# STERLING RANCH EAST PHASE 1

## STERLING RANCH EAST PHASE 1 REZONE

### REZONE EXHIBIT

# V2\_ Zone Map.pdf Markup Summary 1-5-2023

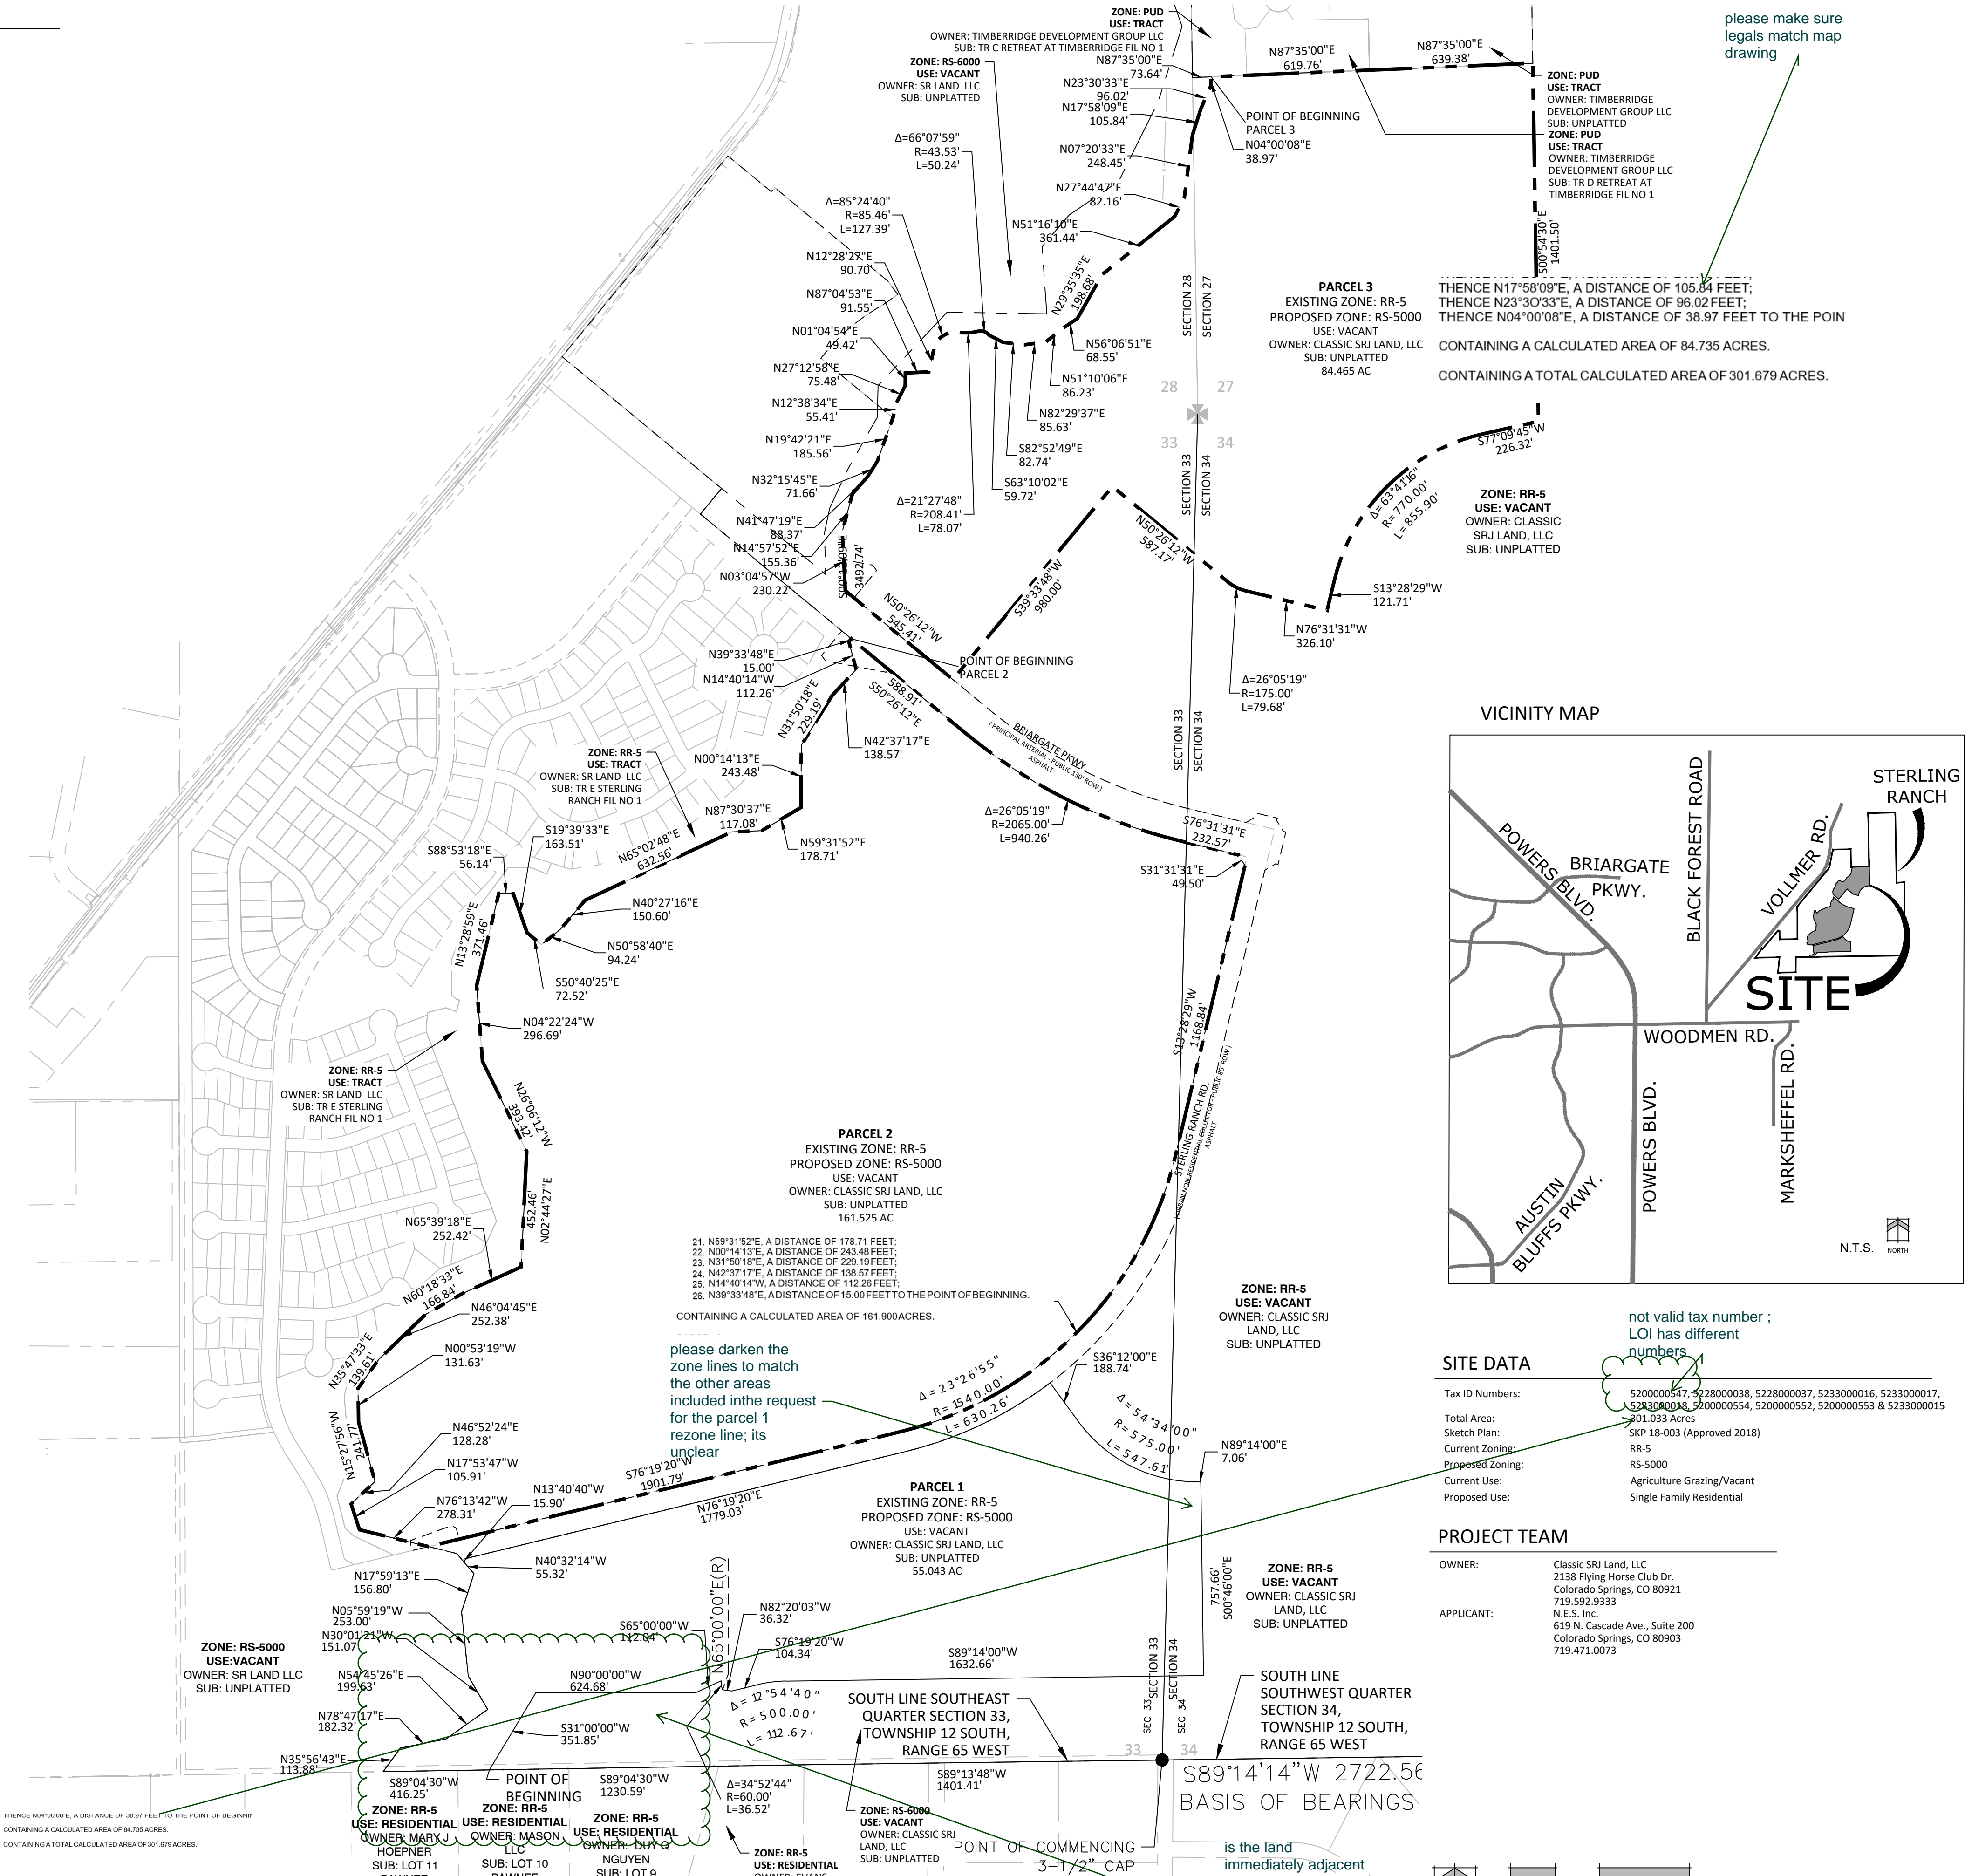
not valid tax number ; LOI has different numbers

This does not match the legal description, nor the application or LOI?

please make sure legals match map drawing

please darken the zone lines to match the other areas included in the request for the parcel 1 rezoned line; its unclear

is the land immediately adjacent to the RR5 in this proposed rs5000? it is conditioned be half acre so should not be included in RS5000- repeat comment
